4. d. Assessment of whether you will meet the minimum LCP performance standards of Chapter III of the industrial emissions directive, or justification that these are not relevant. If you intend to meet them, briefly explain how you will demonstrate achievement of the standard, if integration of the LCP into the cement process complicates this (e.g. BAT-AEL).

Diagram 1 – gas flow through CHP and SCR to the capture plant

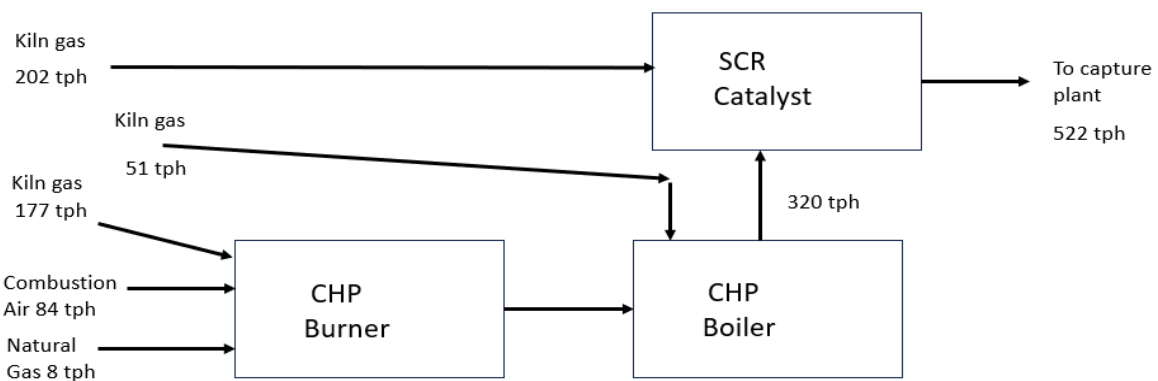
Given the intention to use kiln gas as combustion air, but also to add ambient air, a breakdown of the expected gas volume flows is likely to be needed (from kiln, through LCP, bypassing LCP, added ambient air, total flow to CCP/bypass) for us to fully understand/assess the combined process

The gas flows around the CHP and illustrated in the diagram below for mode 1 operation (the most common mode raw mill and coal mill running) for the normal plant operation. The volume of kiln gases that can pass through the CHP burner is controlled to ensure complete combustion and avoid the production of soot which will lead to increased amine consumption and emission in the Capture plant. The operation of the CHP burners, boiler and SCR will be optimised through detailed design and in plant commissioning/operation to minimise the consumption of natural gas.
